REPORT AMENDED BY STAFF 2-26-87
CITY PLANNING COMMISSION

- APPLICATION:**
- A. Negative Declaration
 - B. Special Permit to establish a restaurant in the EA-2 zone
 - C. Special Permit for a drive-up window

LOCATION: 2426 Fruitridge Road

PROPOSAL: The applicant is requesting the necessary entitlements to establish a 2,500 sq. ft. fast-food restaurant with a drive-up window in the General Commercial Executive Airport-2 (C-2, EA-2) zone.

SITE PLAN

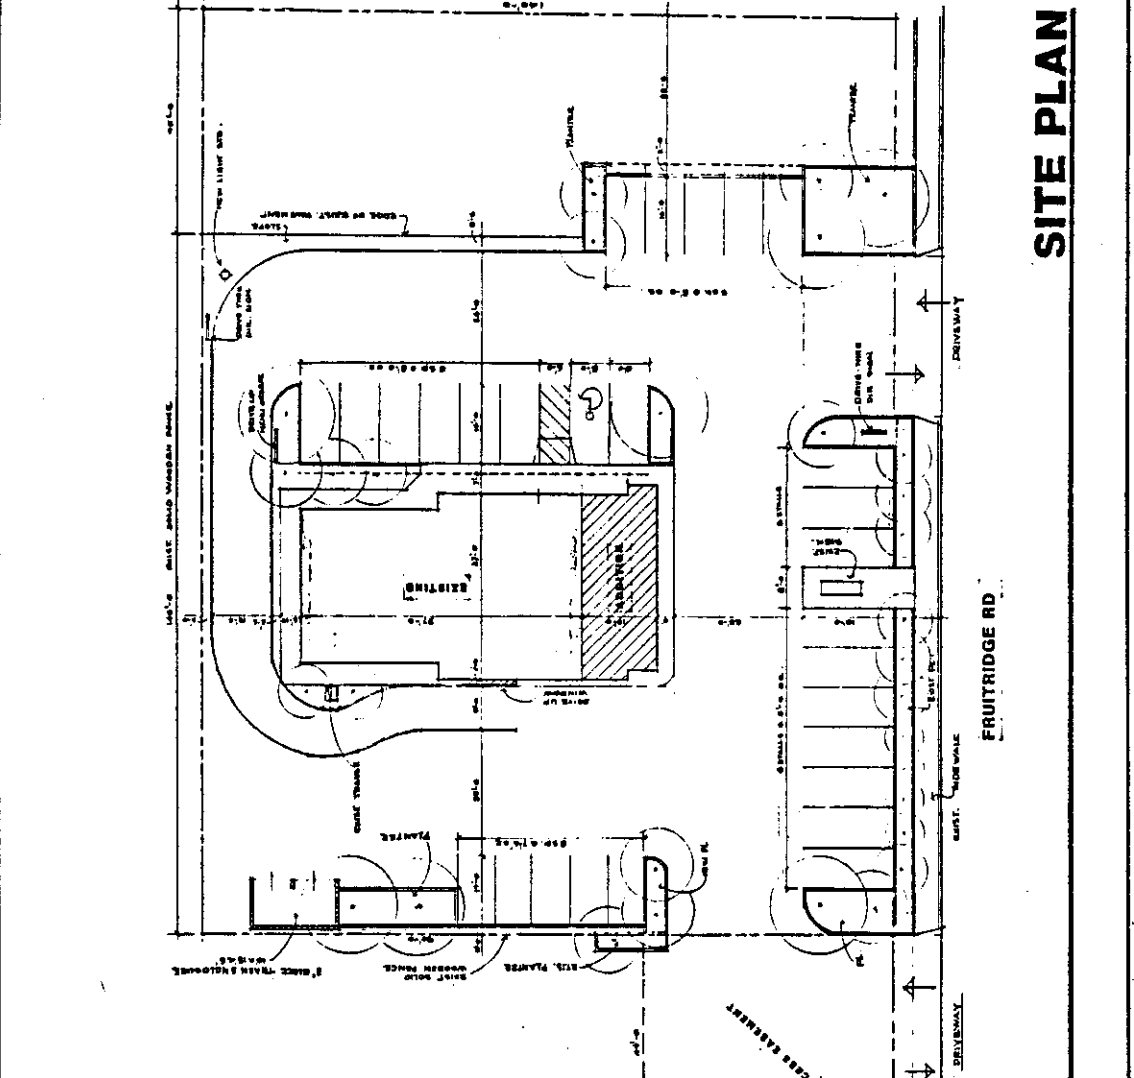
1. Drive-up window lanes will block departing vehicles from the six side stalls when storage lane is full.
2. Full size stalls to be a minimum of 18 feet in depth. Compact stalls to be a minimum of 16 feet in depth.

There is a 50-foot setback required on Fruitridge Road. Plans shall be redesigned to increase the front setback from 48 feet to 50 feet.

1. Seating shall be limited to 58.
2. The applicant shall submit detailed landscaping and irrigation plans for staff review and approval prior to issuance of building permits.
3. The applicant shall redesign the parking lot striping to comply with the Zoning Ordinance dimension requirements and eliminate conflict with the drive-up window stacking space.
4. The site plan shall be redesigned to reflect a 50-foot setback on Fruitridge Road.
5. ~~No/pole sign/shall/be allowed./~~ A monument sign with a maximum height of 12 feet shall be allowed/
5. The applicant shall remove the top illuminated portion of the existing pole sign and repair the remaining portion for use with the current project (staff added)
